Public Works Standard Drawings Subcommittee Meeting

NCTCOG Construction Standards Fifth Edition Division 1000 Drawings

<u>Slides 2 - 3</u>: 1030A, 1030B Interceptor Swale <u>Slides 4 - 5</u>: 1040A, 1040B Diversion Dike <u>Slides 6 - 7</u>: 1050A, 1050B Triangular Sediment Filter Dike <u>Slides 8 - 9</u>: 1080A, 1080B Sand Bag Check Dam <u>Slide 10</u>: 1090 Stone Outlet, Sediment Trap <u>Slide 11</u>: 1110 Pipe Slope Drain

CROSS SECTION

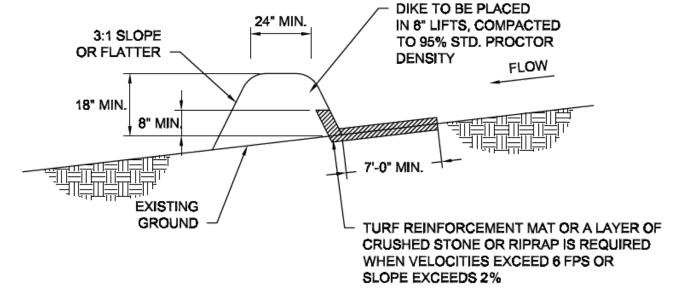
JCI - The TRM should extend beyond the top of banks to match with the TRM details we already are using

1050A

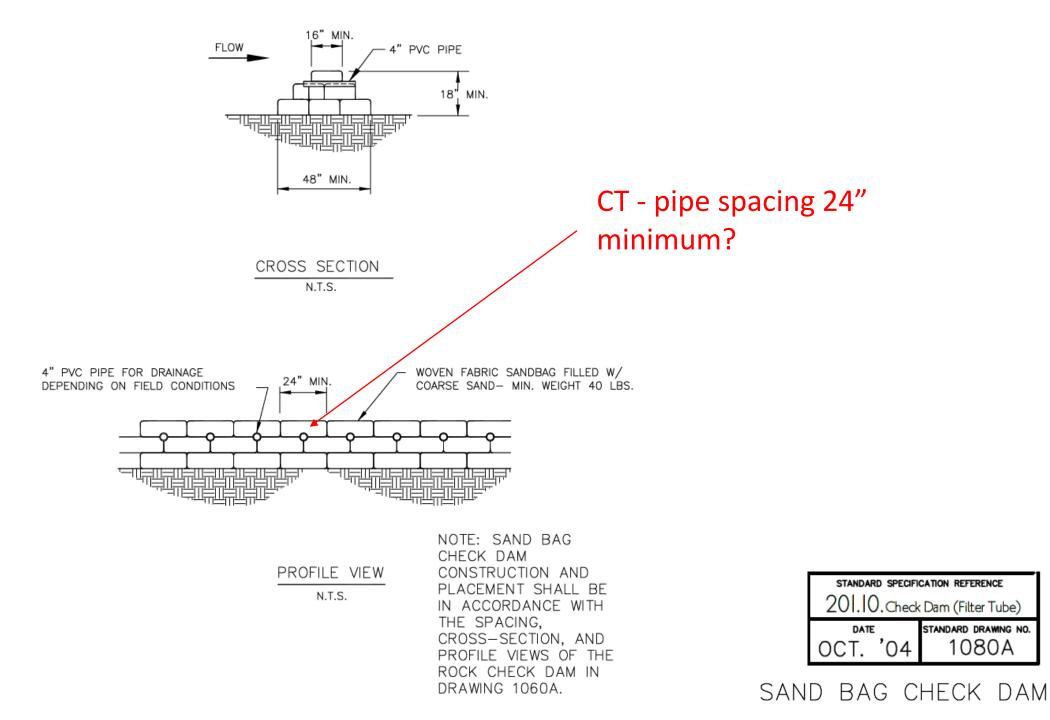
CT - Should there be a maximum length?

SAND	BAG	CHECK	DAM	North Central Texas Council of Governments	STANDAR	D SPECIFI 20	ICATION REFERENCE
					OCT.	'04	standard drawing no 1080B

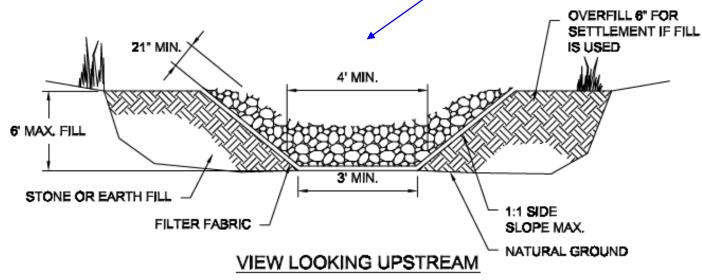
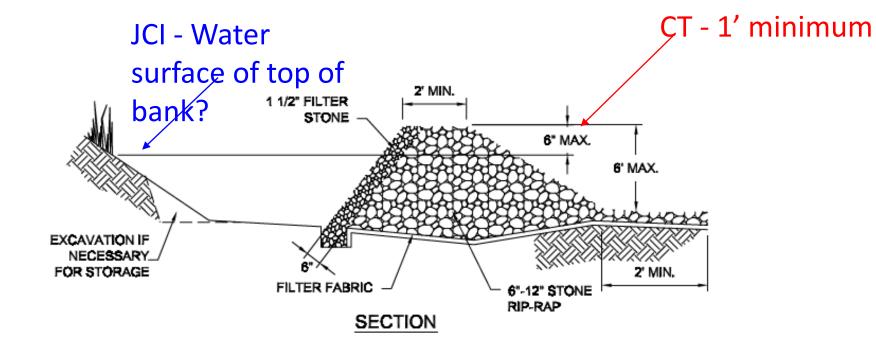
JCI - Is this detal ever used? I have only used the rock check dams.

MP- We have only used the rock check dams. Easier to remove after construction is complete.

standard specification reference 202.12 *								
DATE		STANDARD DRAWING NO.						
OCT.	' 04	1090

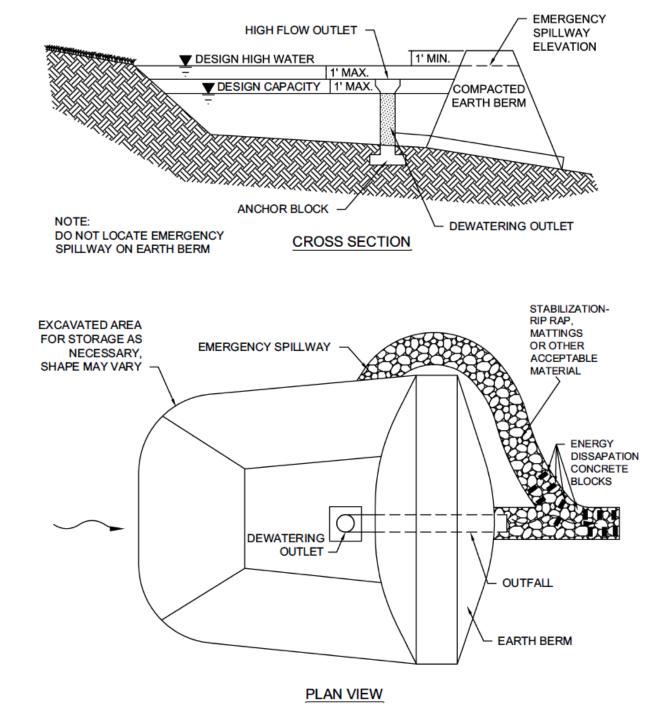
JCI - Is the 4' min for the filter fabric?
